ADDRESS: 415-17 AND 419 S 15TH ST

Proposal: Construct additions

Review Requested: Final approval

Historical Commission Review

Standard 9 Feedback & Objectives

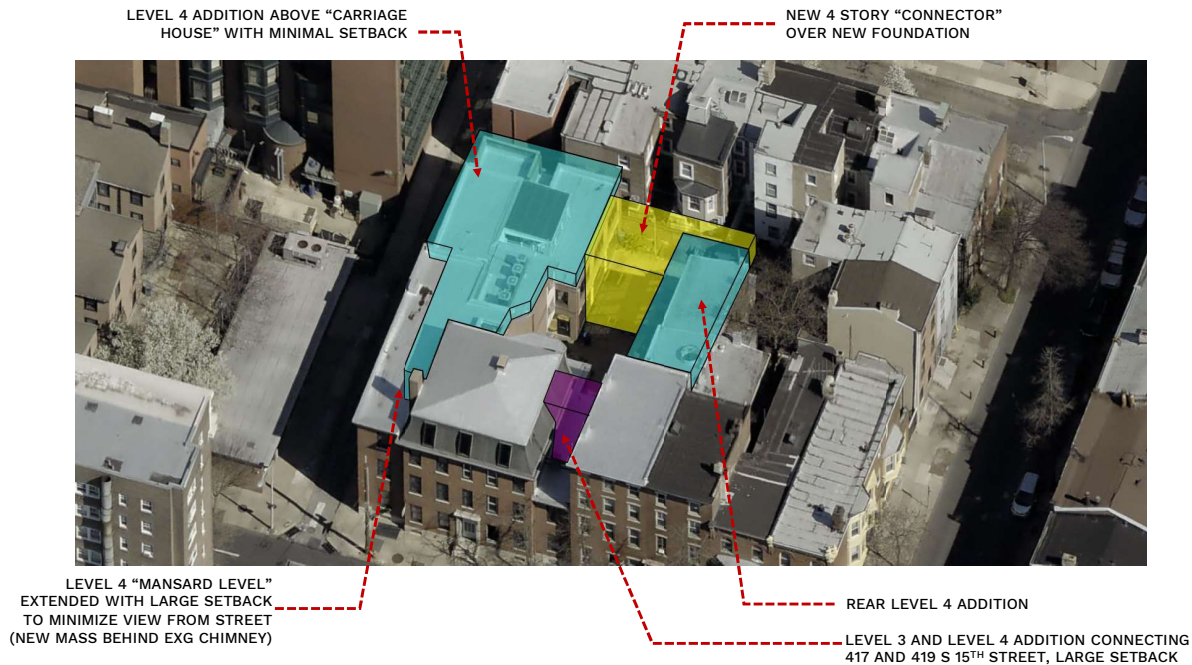
- *The proposed size and massing of the four-story connector at the rear of the properties meets Standard 9. The majority of the connector building will not be visible from the public right-of-way.*
- *The proposed size and massing of the fourth-floor addition at the rear of 419 S. 15th Street meets Standard 9. This addition will not be visible from the public right-of-way.*
- *The proposed size and massing of the fourth-floor addition on 415-17 S. 15th Street at the corner of S. 15th Street and Waverly Street does not meet Standard 9. The addition will be visible from the public right-of-way and remove a portion of the mansard roof. A fourth-story addition could be added to this level and meet Standard 9. To do so, it would need to be set back from the mansard and edge of the building along Waverly Street.*

- Adjusted massing of fourth floor addition along Waverly street to be set back to align with mansard and be fully distinguished from it.

Standard 10 Feedback & Objectives

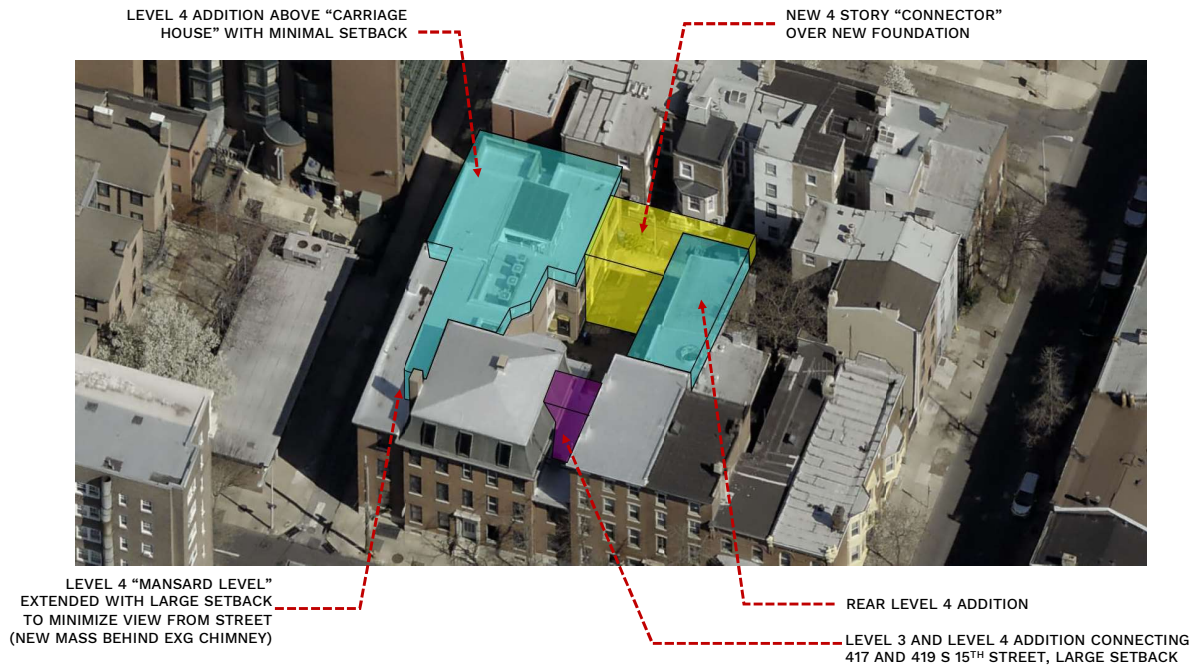
- *The proposed two-story connector along S. 15th Street does not meet Standard 10.*

- Minimize visibility and impact of "connector" between 417-419 at Levels 3 and 4 by utilizing existing openings and using largest possible setbacks from 15th Street.

Roofs Guideline Feedback & Objectives

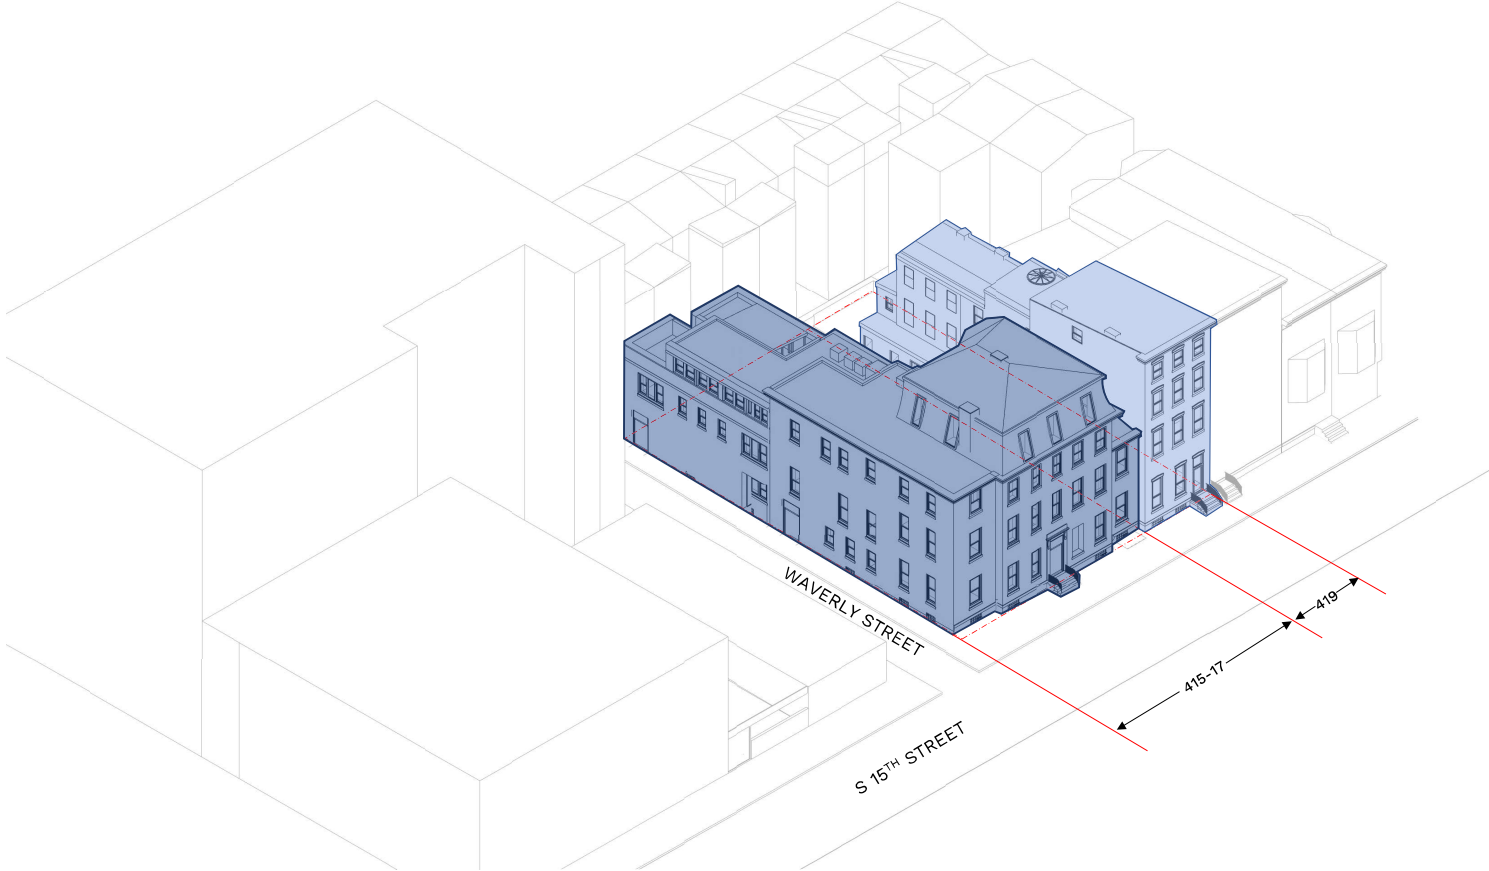
- *The proposed fourth-floor addition on 415-17 S. 15th Street at the corner of S 15th Street and Waverly Street could meet the Roofs Guidelines with proper setbacks.*

- Minimize visibility and impact of this fourth-floor addition by aligning it with the edge of the mansard roof; this allows visual continuity of the mansard's northwest corner to remain from the corner of 15th and Waverly.
